> RE: Level D Survey for Surface Cap: South Meadow Station and Mid-Connecticut Facility Gate 20 - Reserve Road and 300 Maxim Road - Hartford, CT TRC Project No. 31378

This letter is in regards to the Level D survey performed by your company at the South Meadows Facility in Hartford, Connecticut. The survey delineated the extent of a surface cap constructed by TRC in the area TRC designated as EA3B. The survey information provided by your company conforms to the requirements established by statute in the State of Connecticut. However, additional information is required to conform to applicable federal regulations.

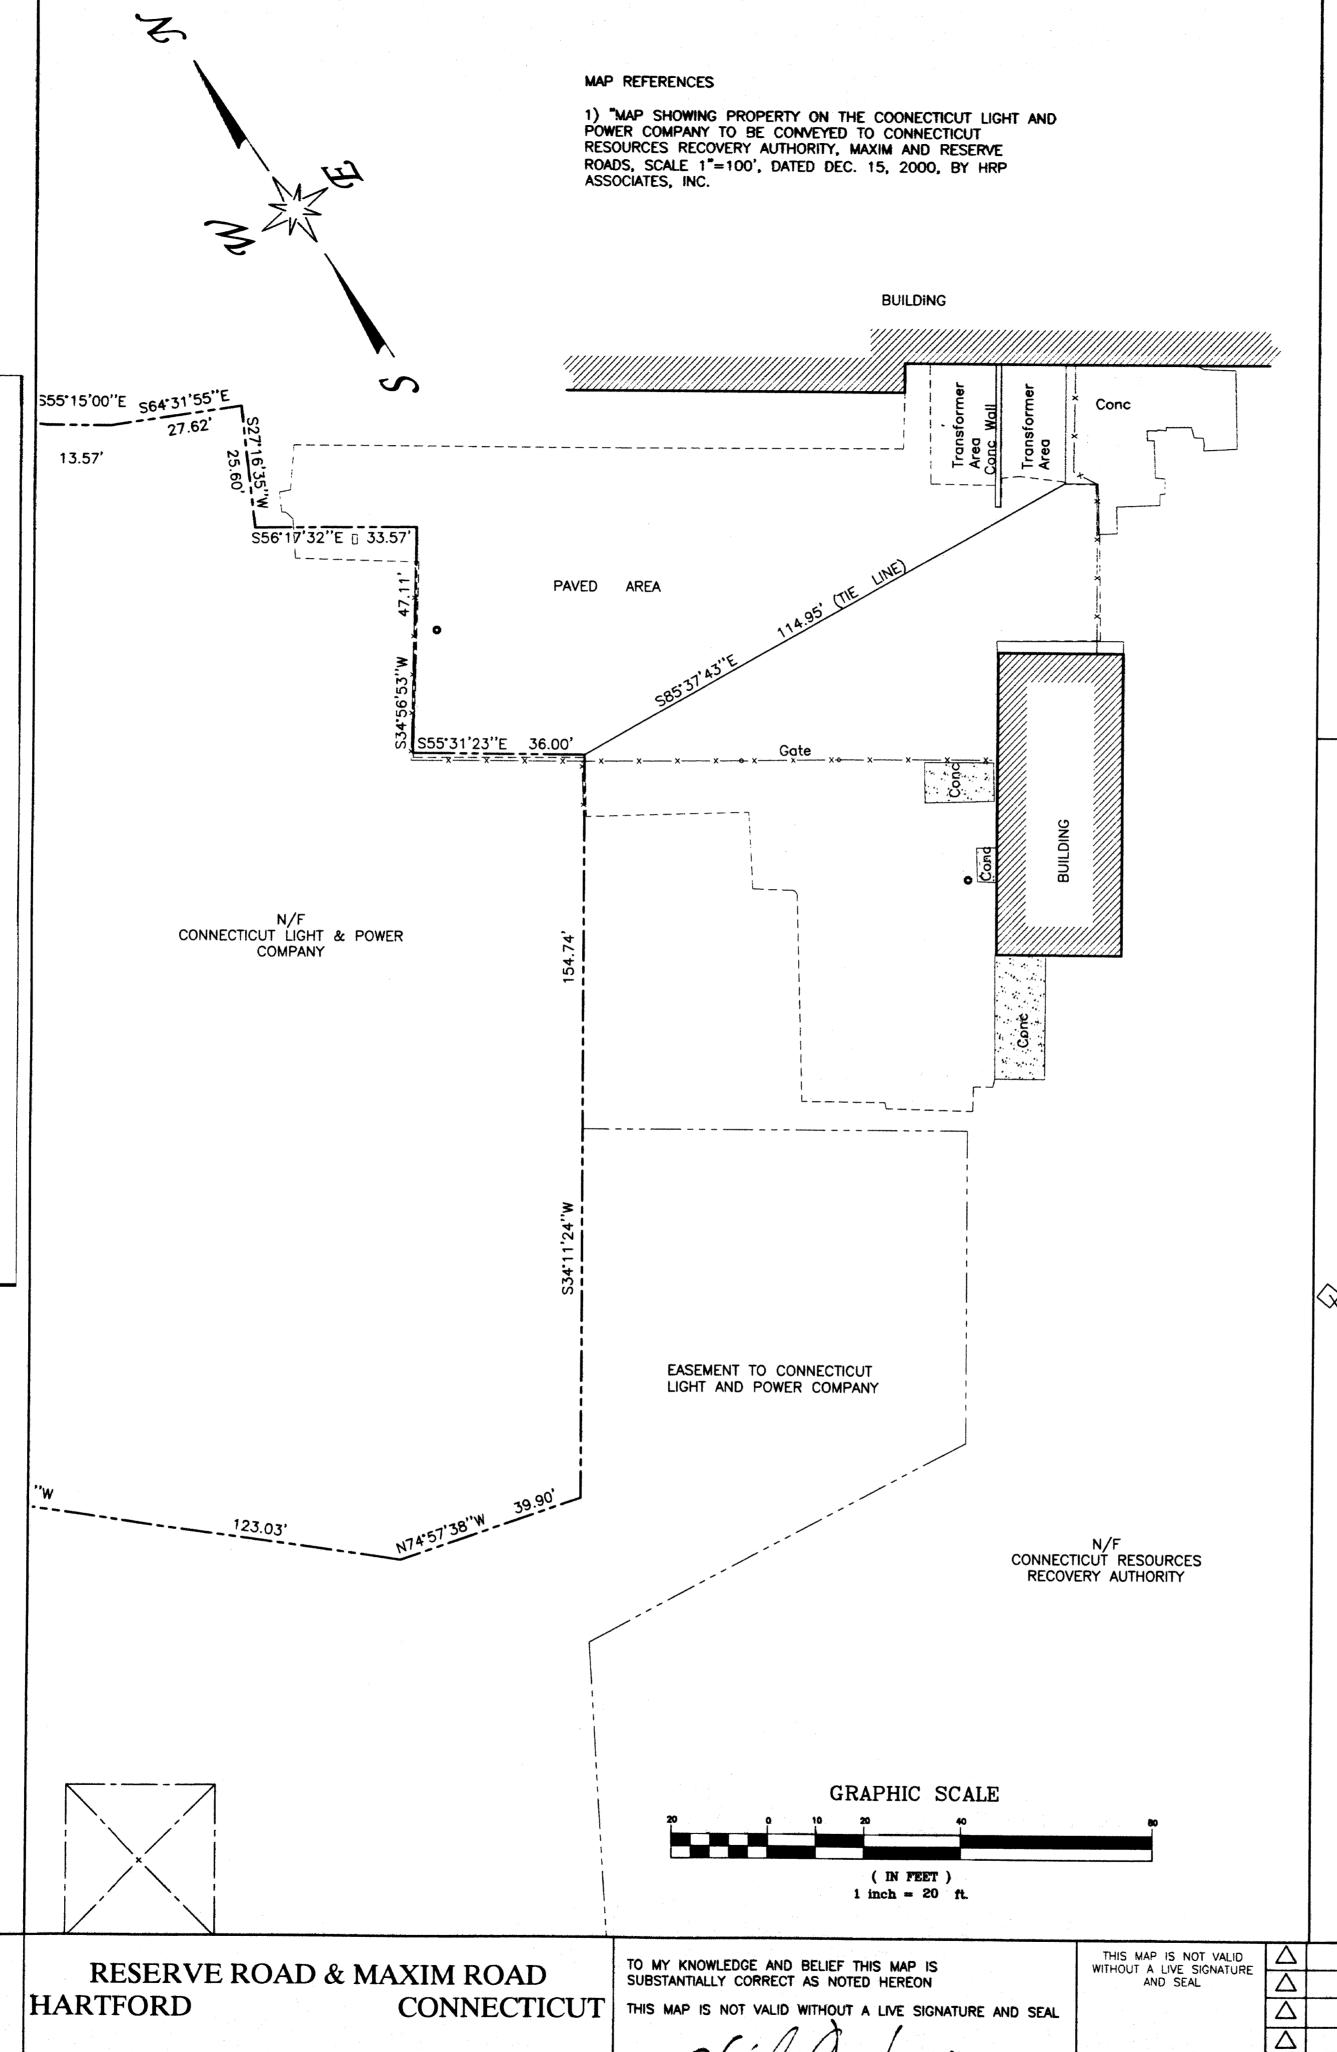
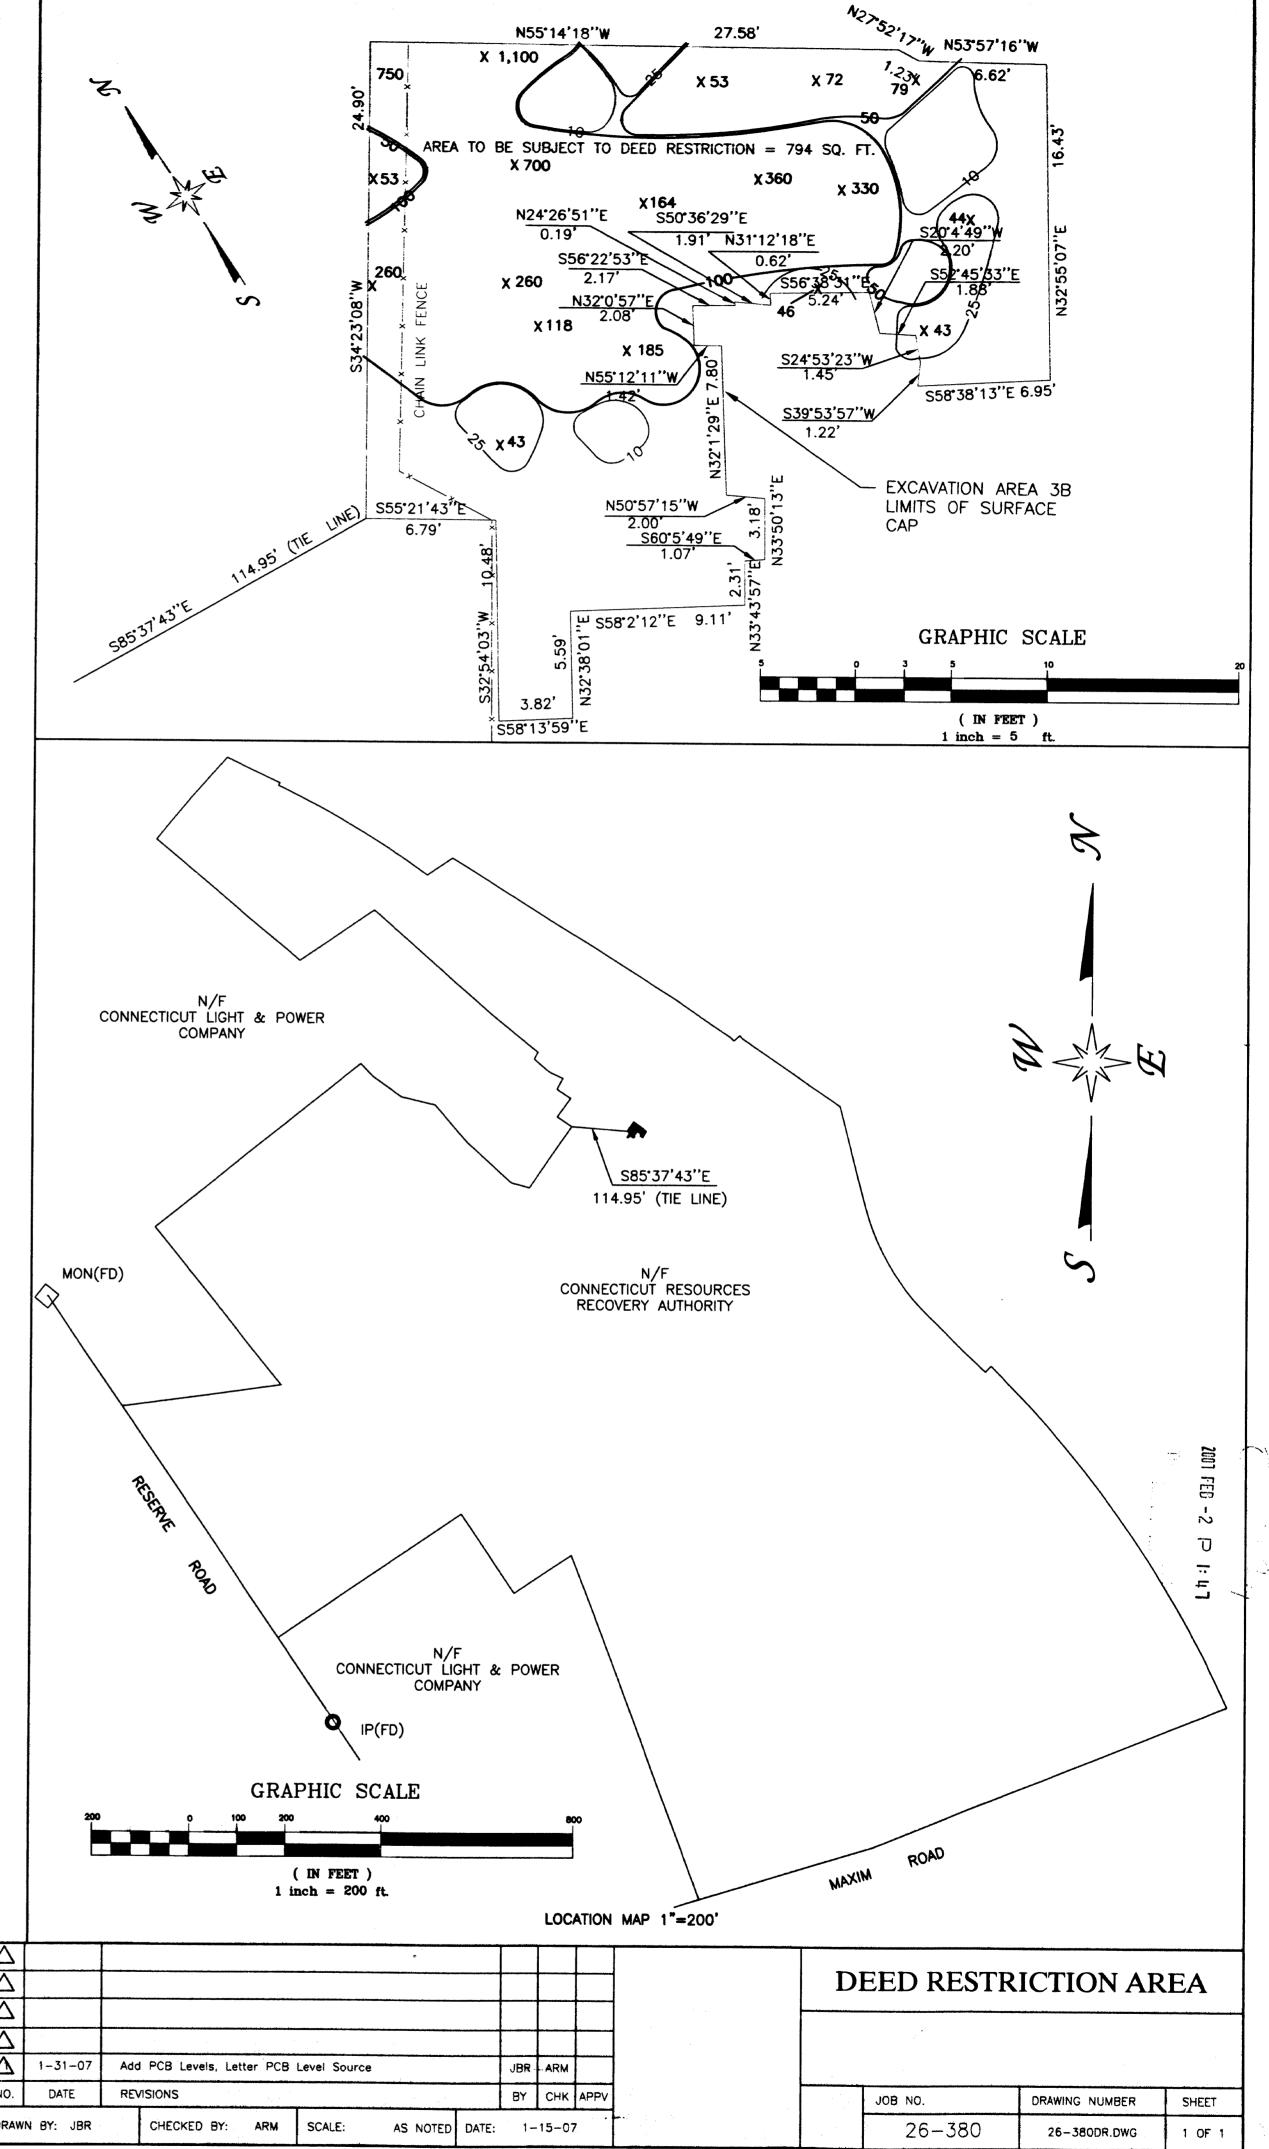
Specifically, the approval letter from EPA Region 1 requires that maps placed on the land record conform with the requirements of \$761.61(a)(8)(A)(3) and that the applicable cleanup levels left at the site, inside the fence, and/or under the cap be indicated. TRC has modified drawings provided by your company so that this information can be included in the information to be filed on the land records for the South Meadows Facility.

TRC acknowledges that Martinez-Couch & Associates were only involved in the survey of the surface features associated with the surface cap and was not involved in any of the data collection associated with determination of PCB concentrations. The information on PCB concentrations was generated solely by TRC as was the map showing the concentrations remaining at the site.
